SUBJECT: ISSUANCE OF AMENDMENT NO. 177 TO FACILITY OPERATING LICENSE DPR-57
AND AMENDMENT NO. 118 TO FACILITY OPERATING LICENSE NPF-5 -
EDWIN I. HATCH NUCLEAR PLANT, UNITS 1 AND 2
(TACs M71501, M71502, M81149 and M81152)

AMENDMENT NO. 177 TO FACILITY OPERATING LICENSE DPR-57 - Hatch Nuclear Plant, Unit 1
AMENDMENT NO. 118 TO FACILITY OPERATING LICENSE NPF-5 - Hatch Nuclear Plant, Unit 2

SAFETY EVALUATION BY THE OFFICE OF NUCLEAR REACTOR REGULATION
RELATED TO AMENDMENT NO. 177 TO FACILITY OPERATING LICENSE DPR-57
AND AMENDMENT NO. 118 TO FACILITY OPERATING LICENSE NPF-5

EDWIN I. HATCH NUCLEAR PLANT, UNITS 1 AND 2

TEMPERATURE PRESSURE LIMITS FOR NON-NUCLEAR
HEATUP, LOW POWER PHYSICS TESTS AND
COOLDOWN FOLLOWING A SHUTDOWN
FIGURE 3.4.6.1-1

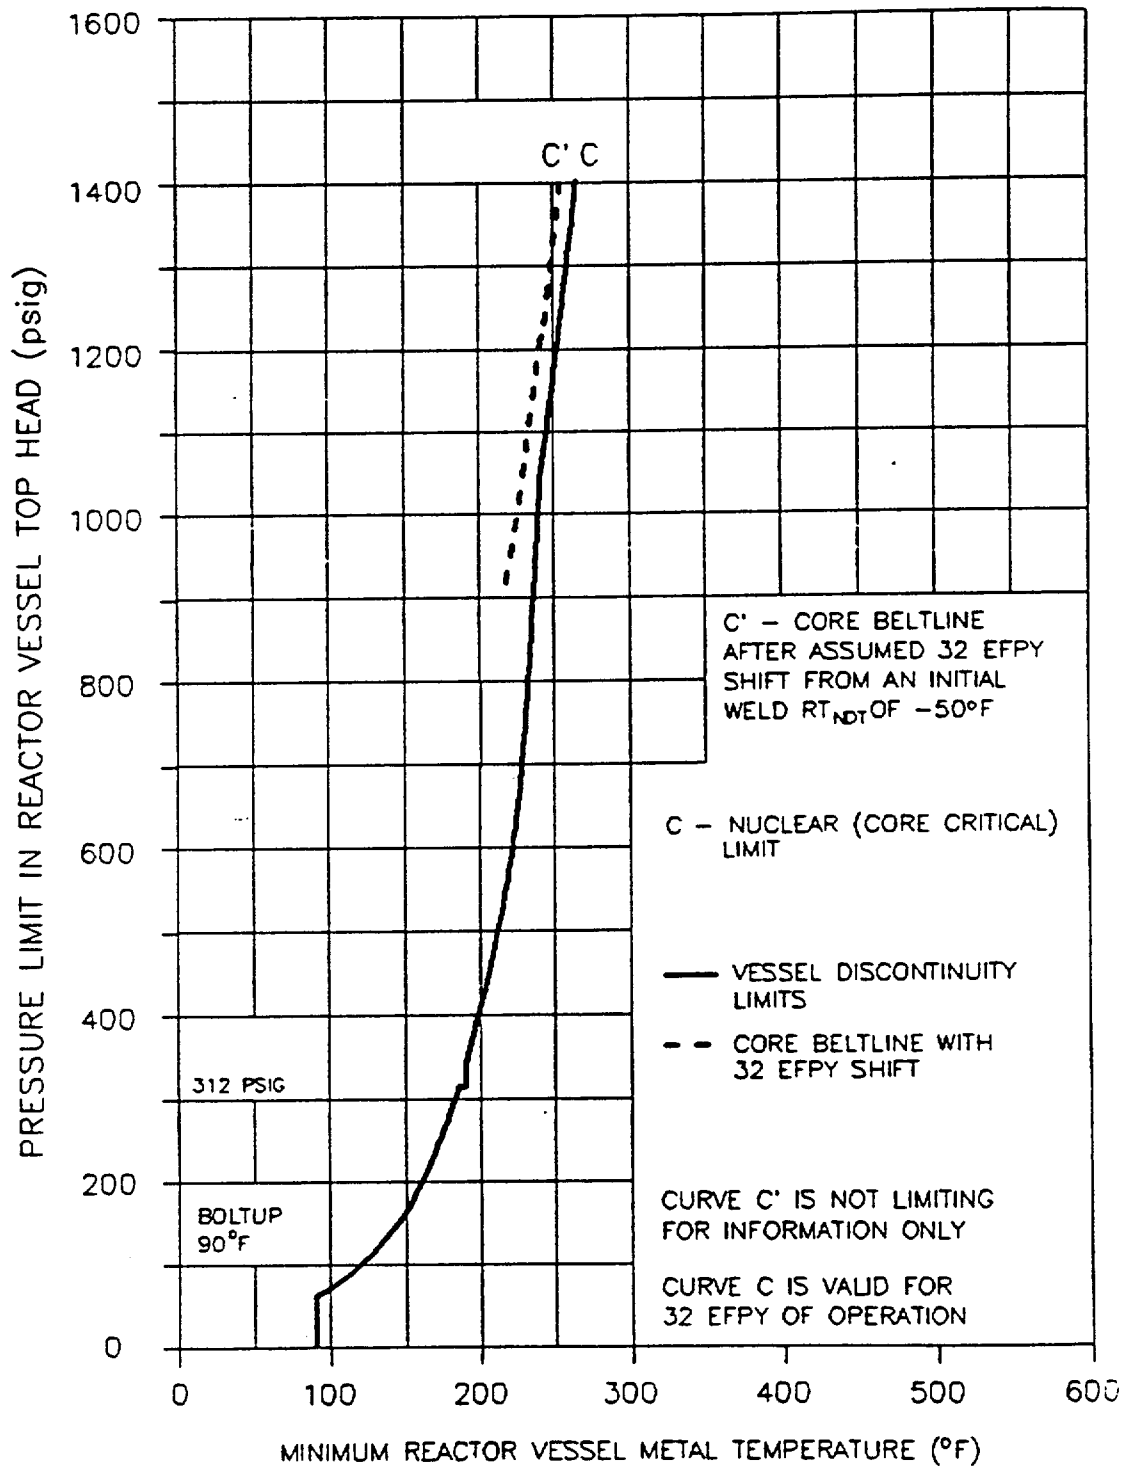
3.4.6.1 The reactor coolant system temperature and reactor vessel pressure shall be limited in accordance with the limit lines shown on (1) Figure 3.4.6.1-1 for heatup by non-nuclear means, cooldown following a nuclear shutdown and low power PHYSICS TESTS; (2) Figure 3.4.6.1-2 for operations with a critical core other than low power PHYSICS TESTS; and (3) Figure 3.4.6.1-3 for inservice hydrostatic or leak testing, with:

The licensee used the method in RG 1.99, Revision 2, to calculate an ART of 69°F at 32 EFY at 1/4T for the same limiting weld metal. The licensee's ART 69°F is more conservative than the staff's ART of 68.8°F and, therefore, is acceptable. Substituting the ART of 68.8°F into equations in SRP 5.3.2, the staff verified that the proposed P/T limits for heatup, cooldown, and hydrotest meet the beltline material requirements in Appendix G of 10 CFR Part 50.

TEMPERATURE-PRESSURE LIMITS FOR CRITICALITY
(INCLUDES ADDITIONAL 40°F MARGIN
REQ'D BY 10CFR50, APP-G)
FIGURE 3.4.6.1-2

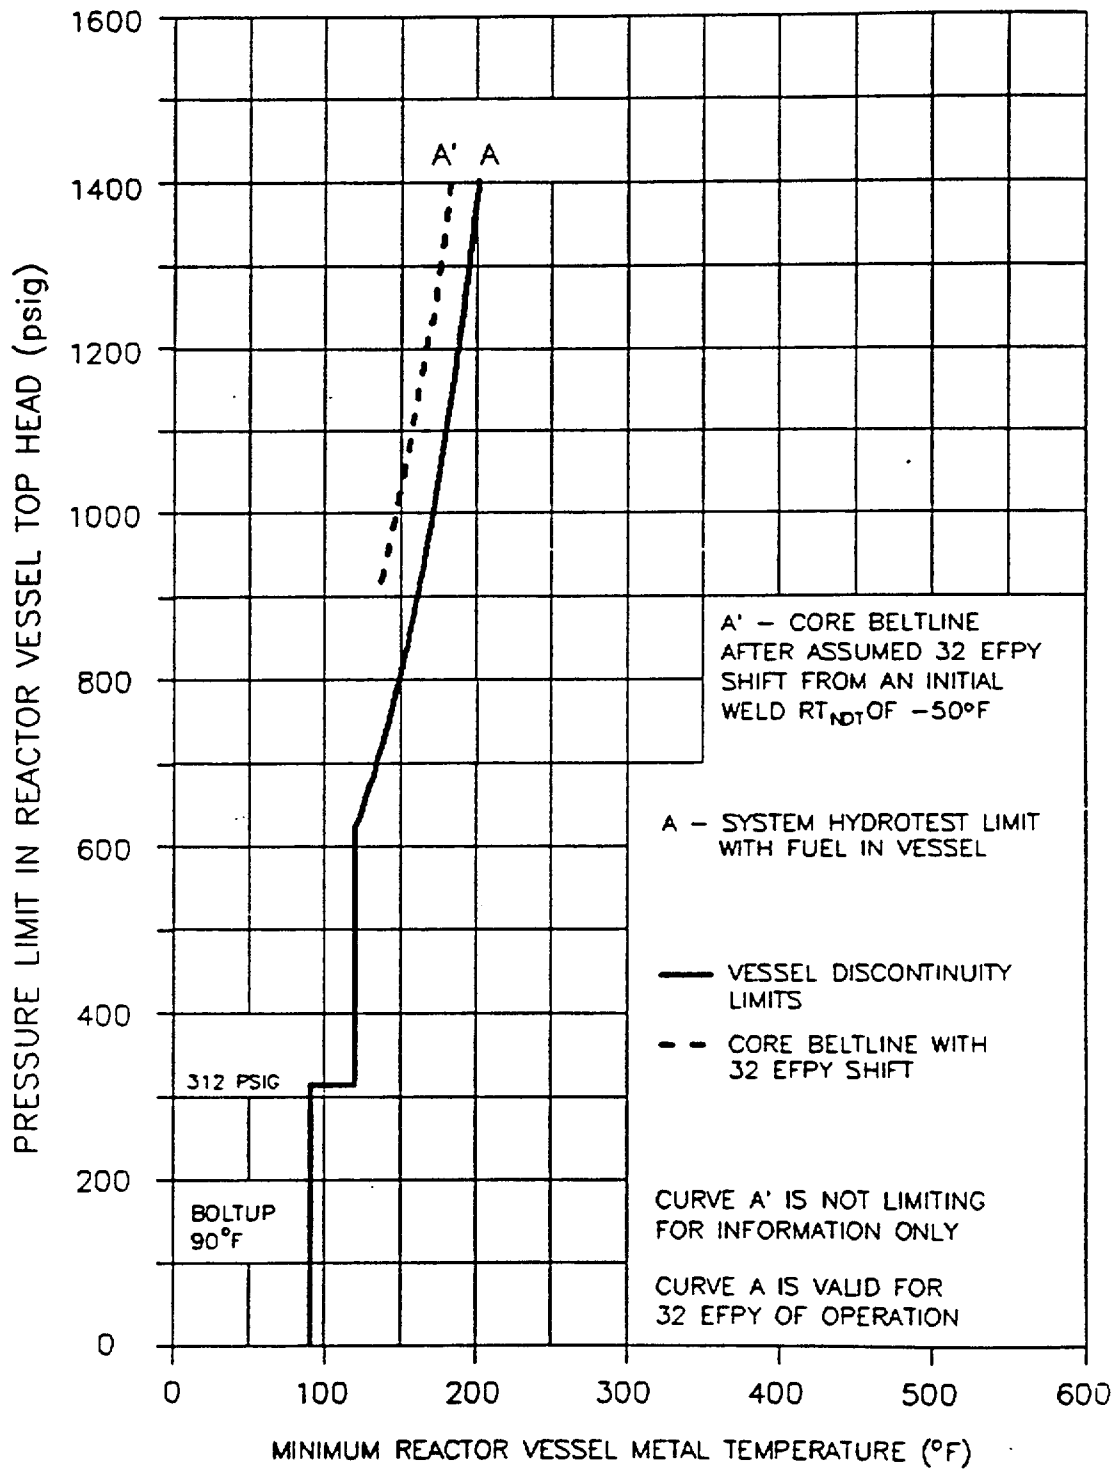
4.4.6.1.2 The reactor coolant system temperature and reactor vessel pressure shall be determined to be to the right of the criticality limit line of Figure 3.4.6.1-2 within 15 minutes prior to the withdrawal of control rods to bring the reactor to criticality.

The pressure-temperature limit lines shown in Figures 3.4.6.1-2 and 3.4.6.1-3 for reactor criticality and for inservice leak and hydrostatic testing have been provided to assure compliance with the minimum temperature requirements of Appendix G to 10 CFR Part 50 for reactor criticality and for inservice leak and hydrostatic testing.

Bases Figure B 3/4.4.6-1
Adjusted Reference Temperature for Limiting Beltline Materials

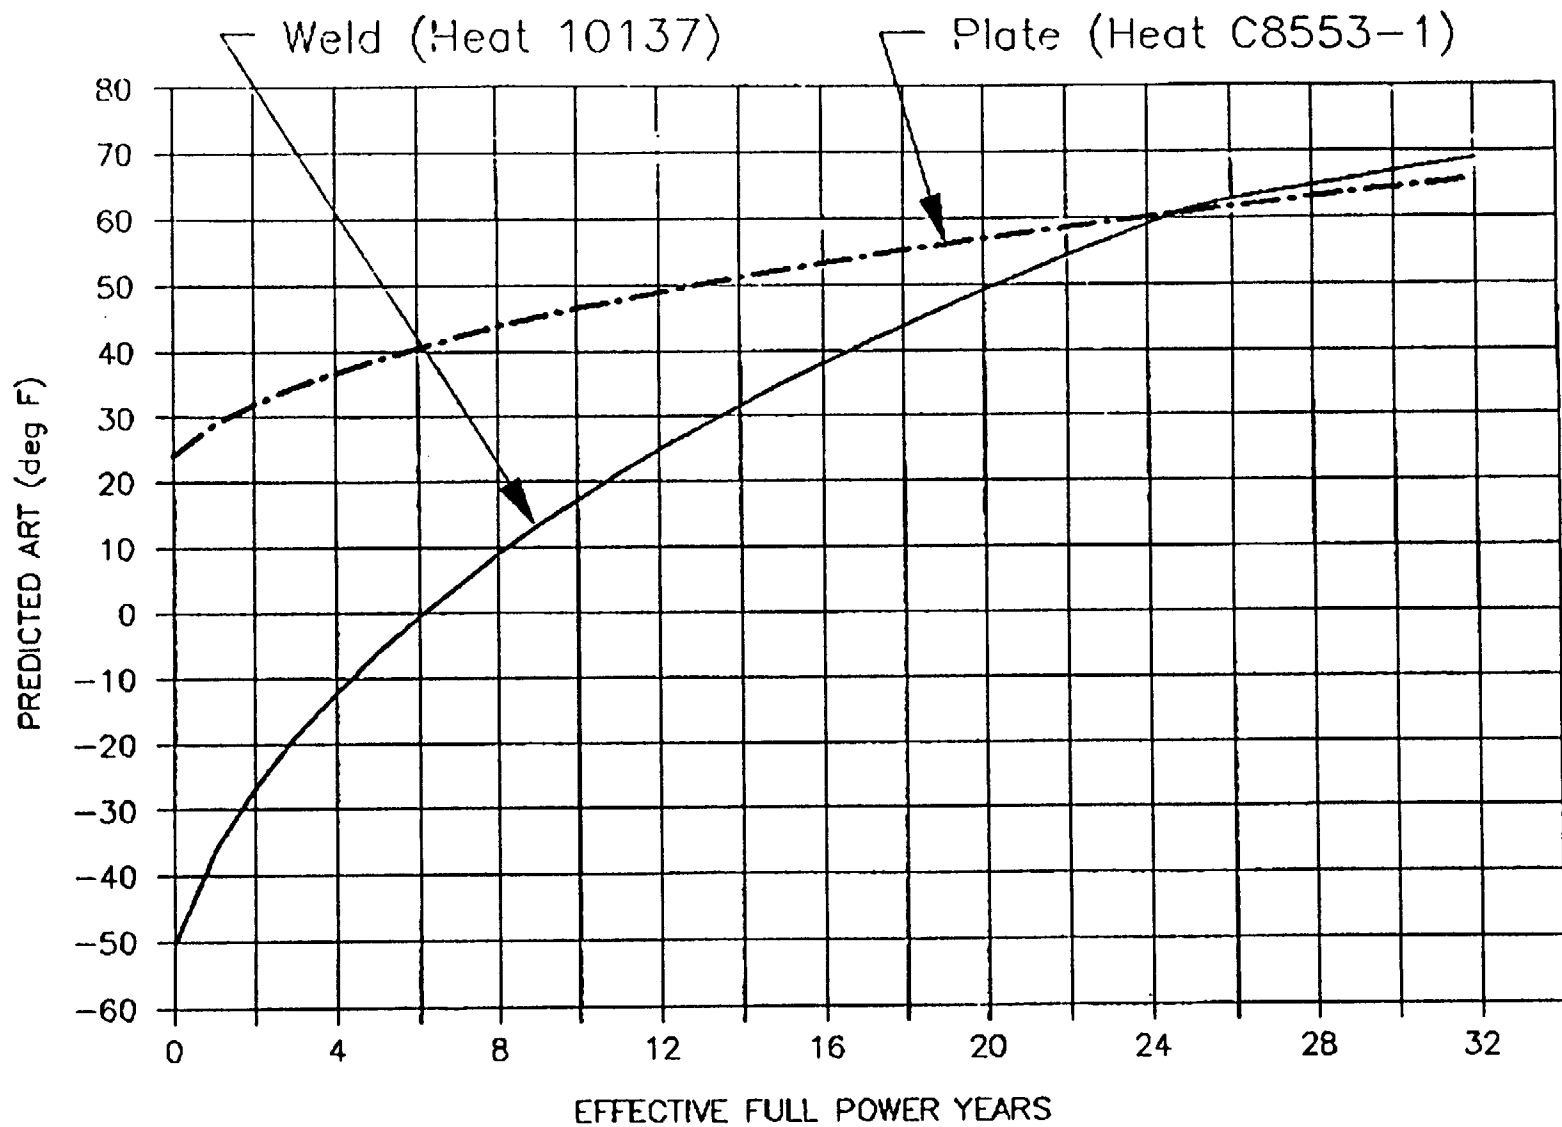
The reactor vessel materials have been tested, and analyses performed to determine their initial RT_{NDT} values. Reactor operation and resultant fast neutron ($E > 1$ MeV) irradiation will cause an increase in the RT_{NDT} values of the beltline materials. Adjusted reference temperatures, based upon the fluence, have been predicted using Regulatory Guide 1.99, Revision 2, and the beltline material test results. The adjusted reference temperature for the most limiting beltline material is plotted versus EFPY of operation in Bases Figure B 3/4.4.6-1. The pressure/temperature limit curves, shown in Figures 3.4.6.1-1 through 3.4.6.1-3, include predicted adjustments in RT_{NDT} for 32 EFPY of operation. Comparison with the nonbeltline curves shows the nonbeltline curves are limiting for 32 EFPY of operation.
